COA-0030-2019

529 EUCLID STREET
OAKWOOD HISTORIC
DISTRICT (R-10)

Nature of Project:
Construct addition and rear deck

APPLICATION FOR A CERTIFICATE OF APPROPRIATENESS – STAFF REPORT

Tree Protection Plan
Katie Rose Levin
ISA Board Certified Master Arborist
SO-6744B

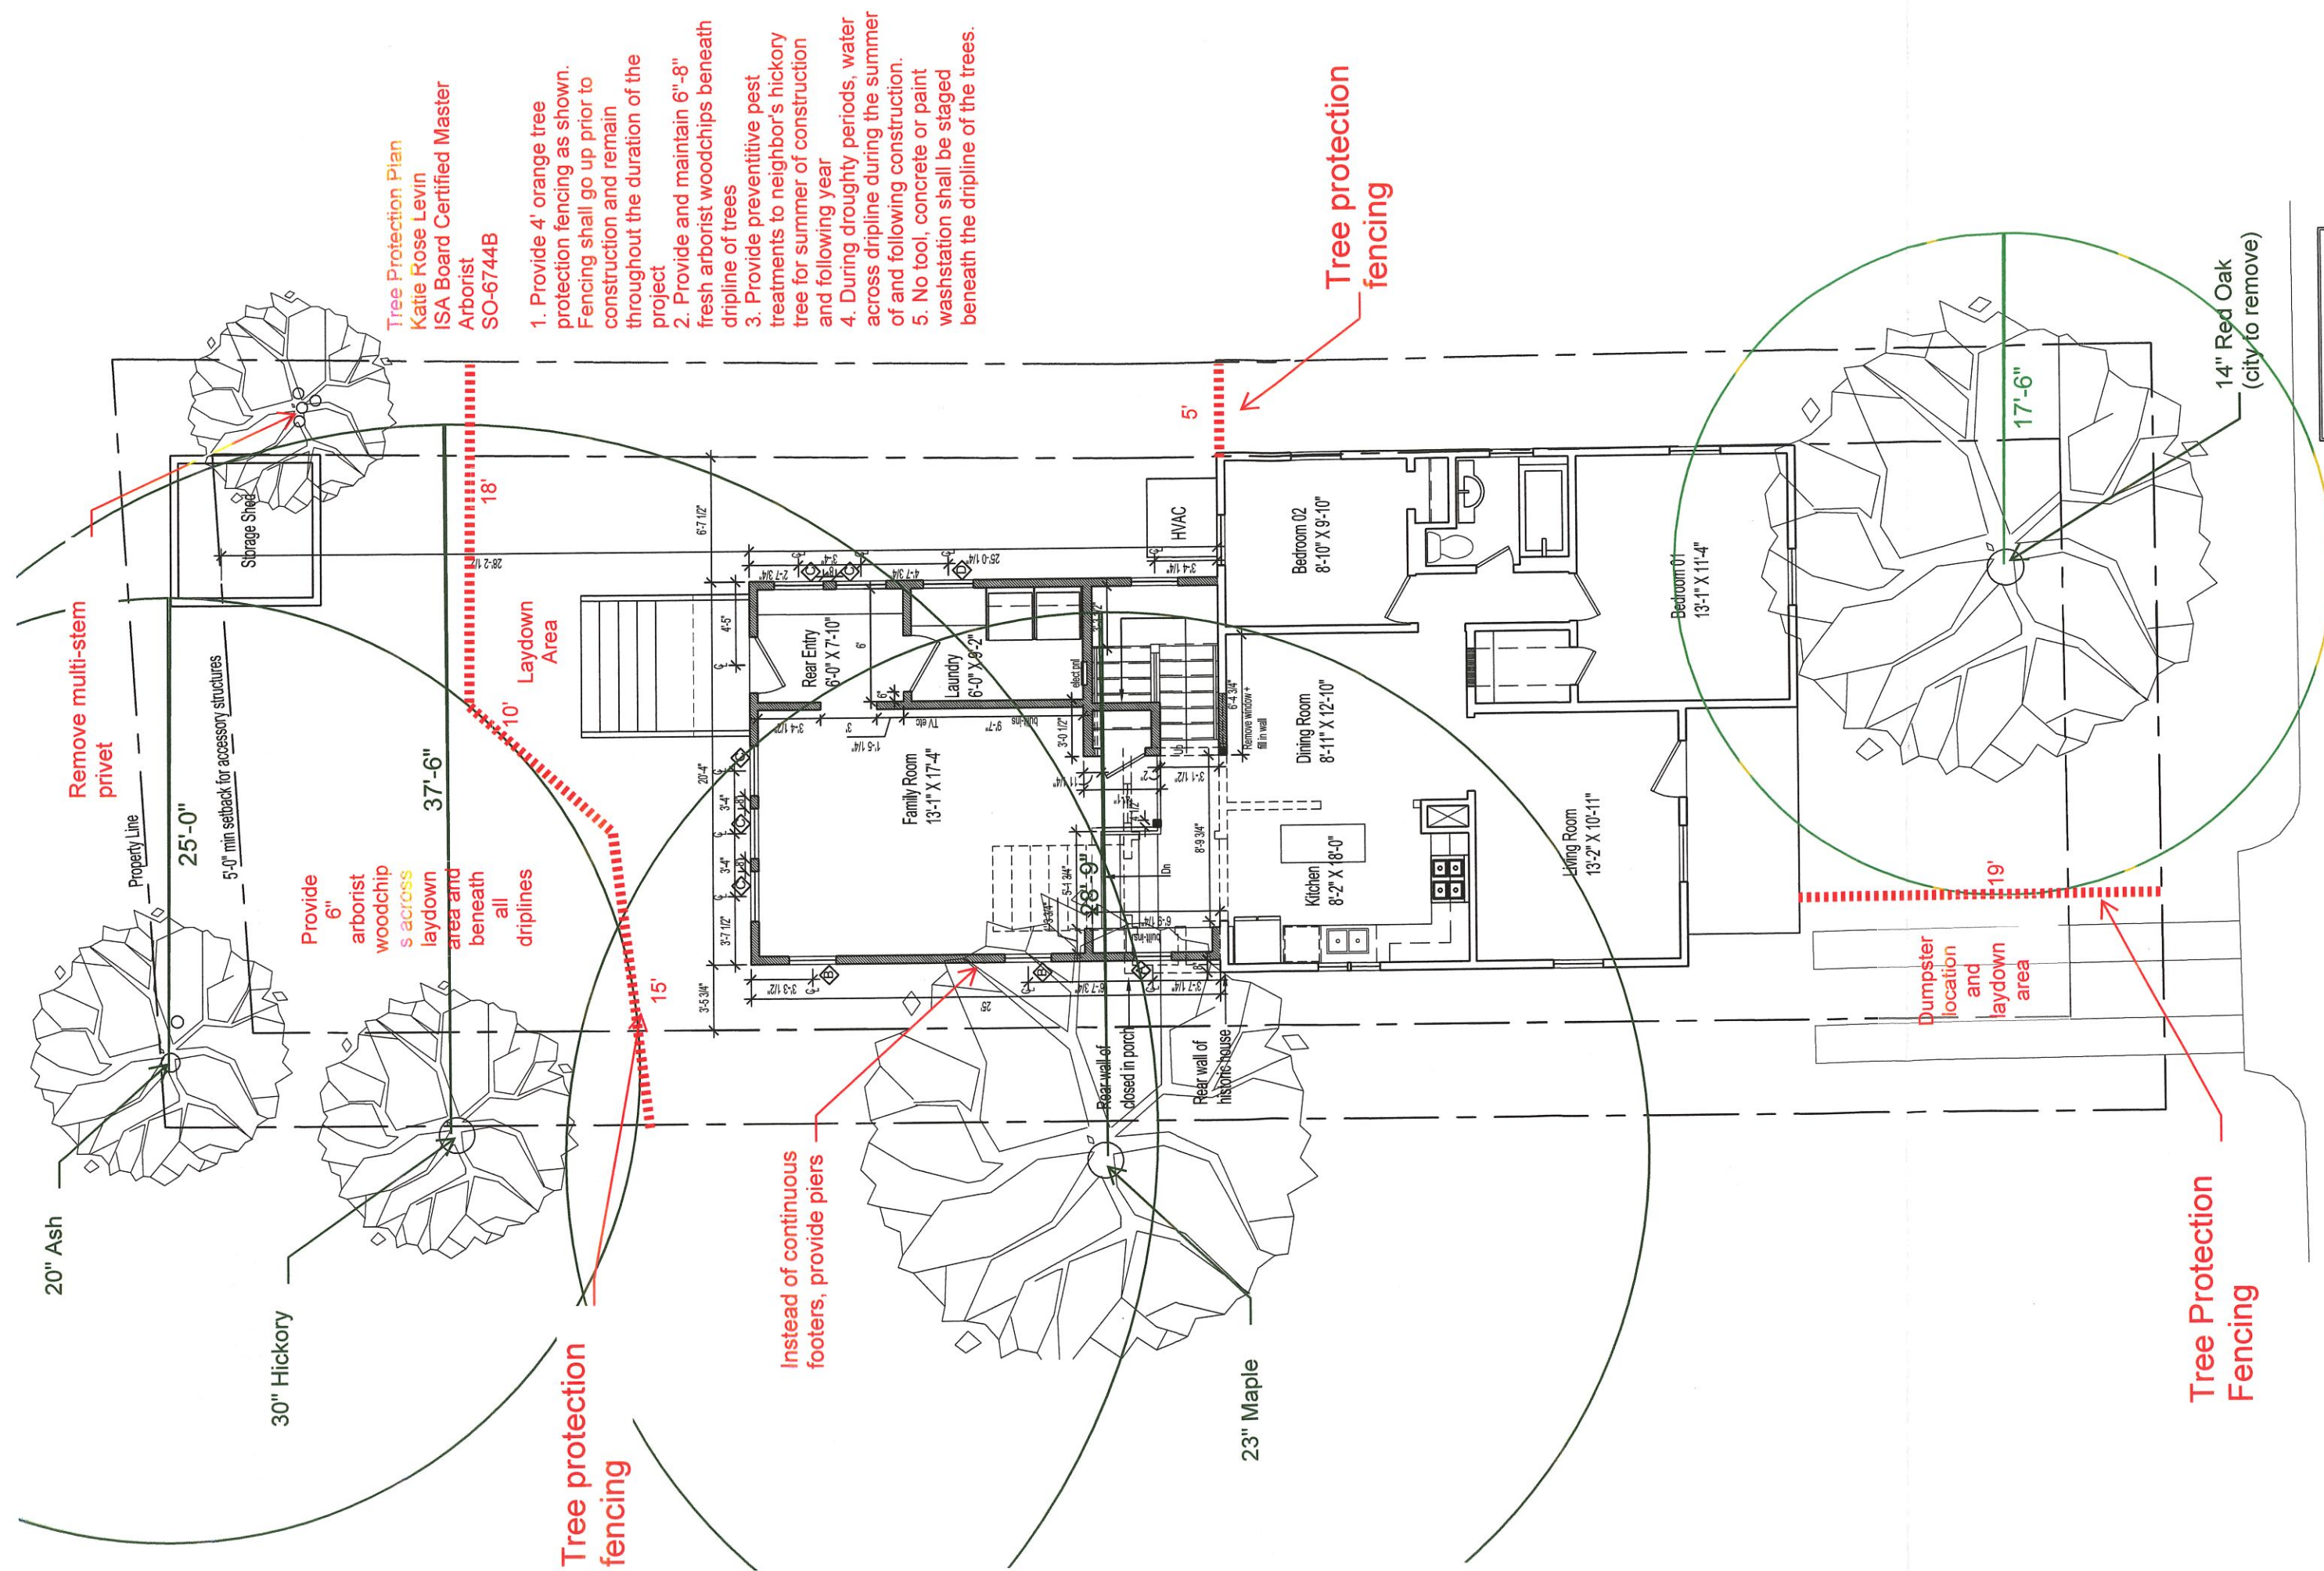
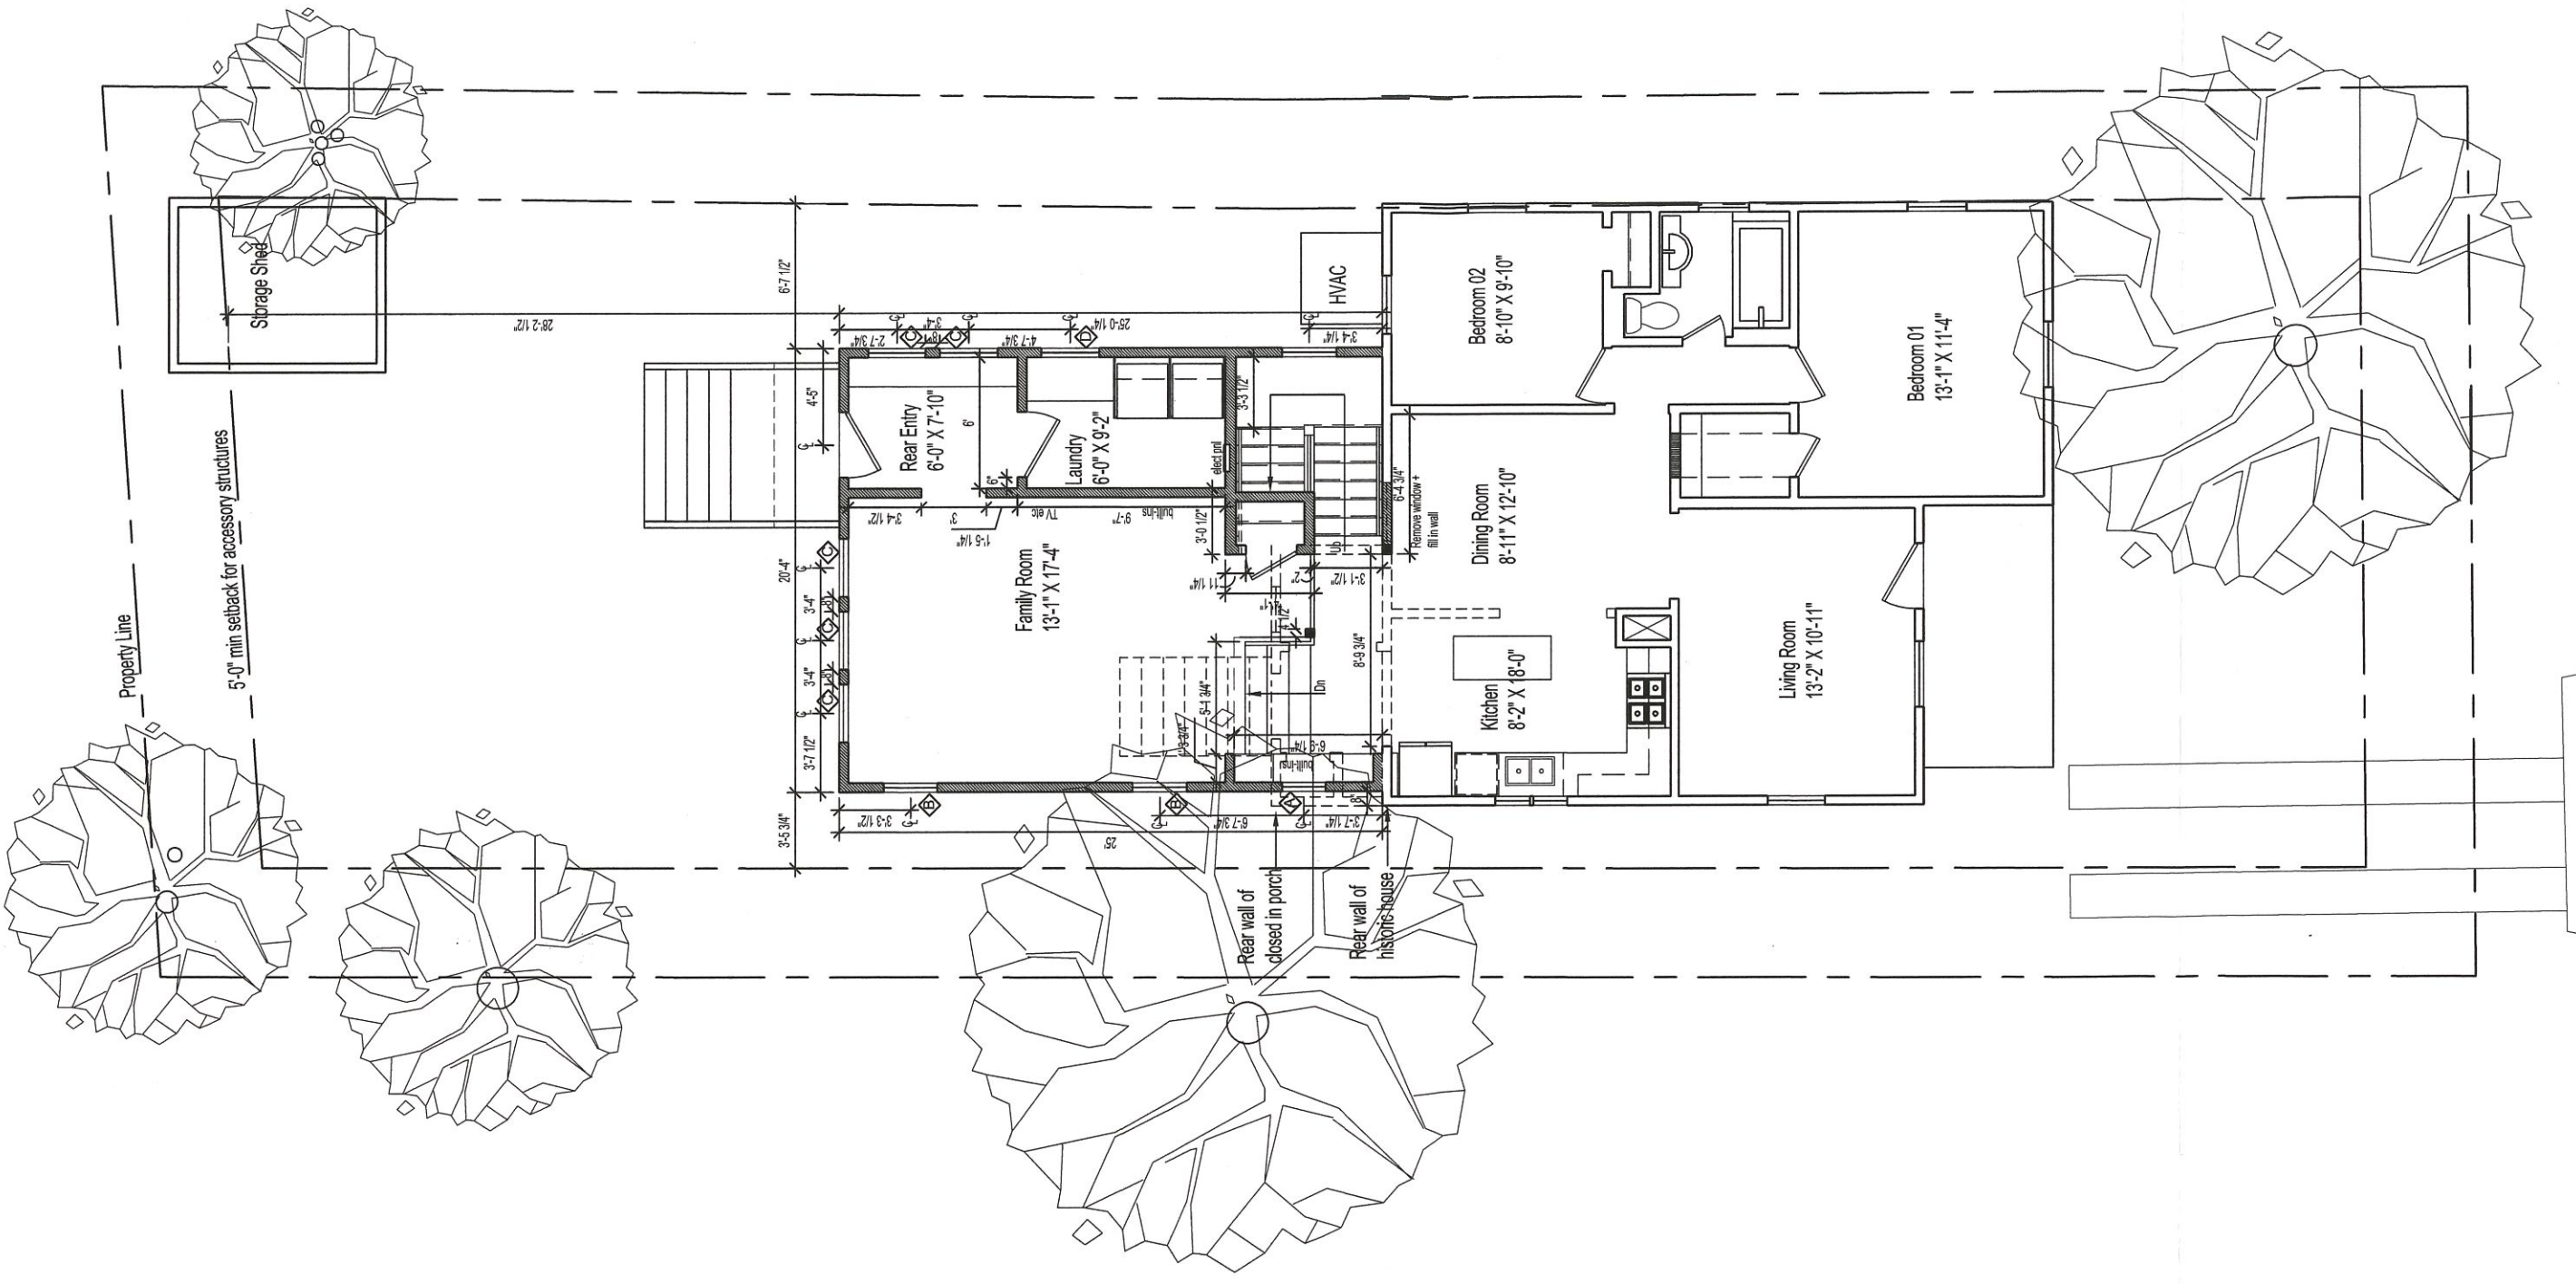
- 6* The application notes the slope of the property and illustrates the grade in the elevation drawings. The addition is set in the Critical Root Zone of a 23” DBH Maple located on the neighboring property. The tree protection plan notes that piers should be utilized instead of a continuous footer.

- 13* A tree protection plan prepared by a certified arborist was provided that identified the location and species of trees with critical root zones on the property. It includes tree protection fencing that appears to accommodate construction activity, laydown areas, and mulched areas.

1. That a tree protection plan be implemented and remain in place for the duration of construction.
2. That the addition be constructed using piers rather than a continuous footer.
3. That the following be provided to and approved by staff prior to installation or construction:
 - a. Exterior lighting, if any.
